24/01861/FUL Chipping Norton Road, Little Tew, Oxfordshire

Planning Application 24/01861/FUL Land at E 437424 N 228877 Chipping Norton Road,
Little Tew:

Landscape and Visual Matters: Review of Development proposals

Landscape Review Technical Note

Figure 2. Landscape types in Character Area 'Ironstone Valleys and Ridges, West Oxfordshire Landscape Character Assessment

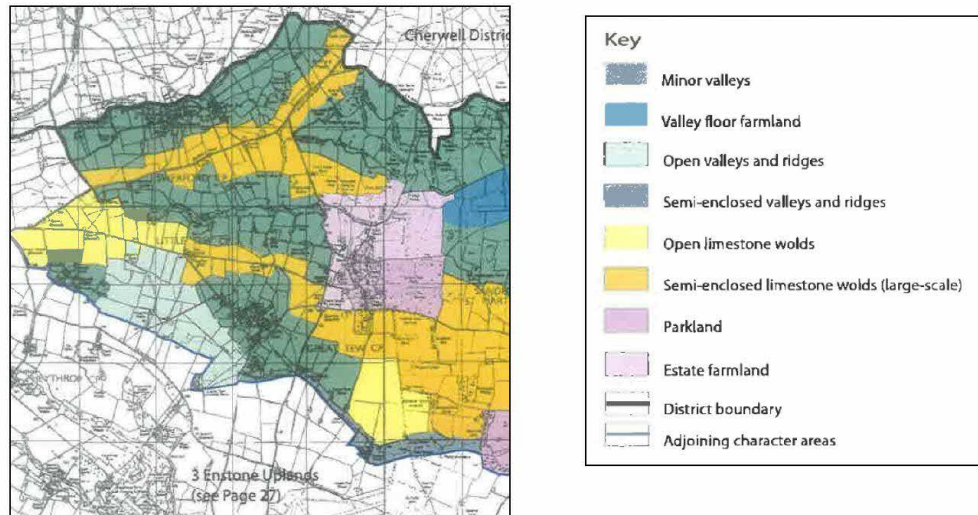
24. Whilst this LCT is found within the wider landscape it is not relevant to the landscape of the site or the landscape setting of Little Tew. This can be seen clearly in Figure 2. The LVIA identifies that the Parkland and Estate LCT are 'highly distinctive landscapes associated with large country houses and estates where a formal or designed character has been imposed upon the underlying landscape.' These are historic estates and parklands and clearly of value for both heritage and landscape reasons. Their existence is not coincidental but derives from the historic evolution of the landscape. They are therefore complex landscapes with strong associations with wider farmland and settlements. Although the historic estates and parklands are stated to have been imposed upon the underlying landscape, I consider it more accurate to say that they have evolved as a result of culture and land use over centuries as have all of the local landscapes. Parkland is therefore a landscape characteristic that cannot be added to a landscape to achieve enhancement any more than a new dwelling built in the vernacular style and in local materials can be dropped into the landscape.

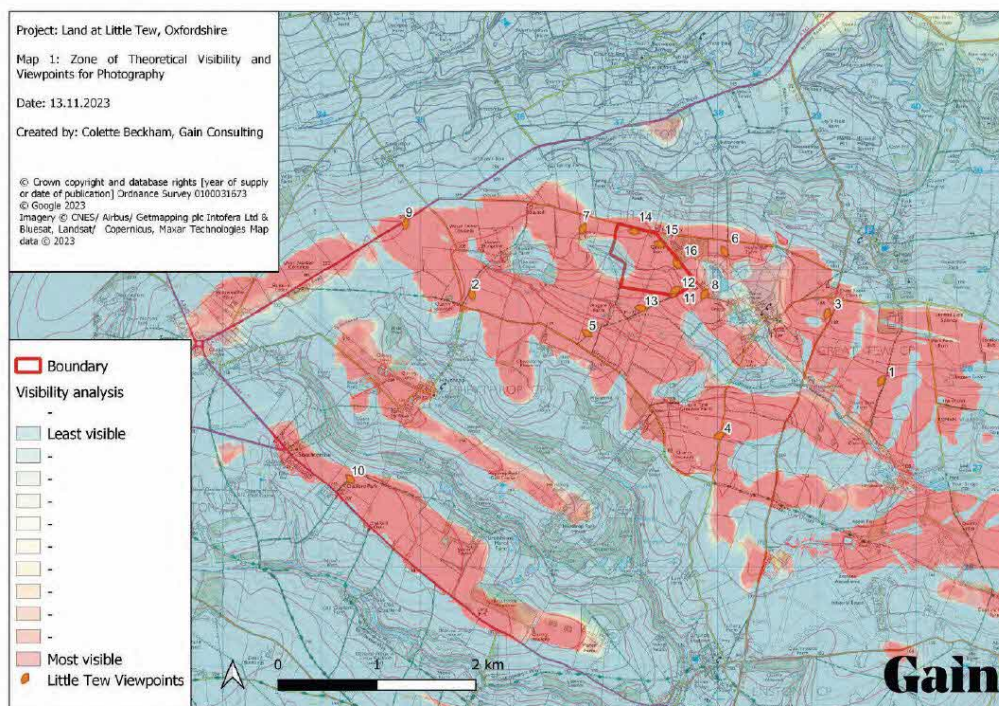
30. The ZTV illustrates the potential visibility of a new building up to 10 metres tall. The LVIA states in 6.2 that the 10m scenario is deemed the worst-case scenario. However, elevations within the application documents state that the building is 10.737m in height excluding chimney and pedestal on which the main house is located (illustrated by a number of steps). When these are taken into account, I consider that it may have been more helpful and realistic to produce a ZTV based on a 12m tall building. However, it remains clear that the ZTV produced illustrates a significant potential for built form to be seen in views from the wider landscape.

31. The LVIA ZTV clearly identifies that there are potential views over a wide area to the east, west and to the south. As the building is designed to take advantage of these potential long views, this is perhaps not surprising, Views from the north appear quite limited and I generally consider that these views would be limited to the road and local residences off the road. Overall, the LVIA concludes that views of built form will be highly limited and restricted

to a number of locations in the immediate vicinity of the site. I do not agree that these are limited to the immediate vicinity but will be experienced from a much longer distance from the south, south east and from the south west. I also do not agree with the LVIA where it states that where the views will be seen, they will be positive changes. This implied positive change is based on the value attributed by published assessment to parkland within the existing landscape and that seeing new parkland will be as positive of views of historic and long established parkland. This assessment is incorrect. Introducing views of a house and its parkland into a landscape distinctive for its exposed, sparsely settled and representative rural characteristics would be harmful as the parkland and house would have no historic context and be meaningless in a landscape where they have not evolved as part of the wider agricultural landscape.
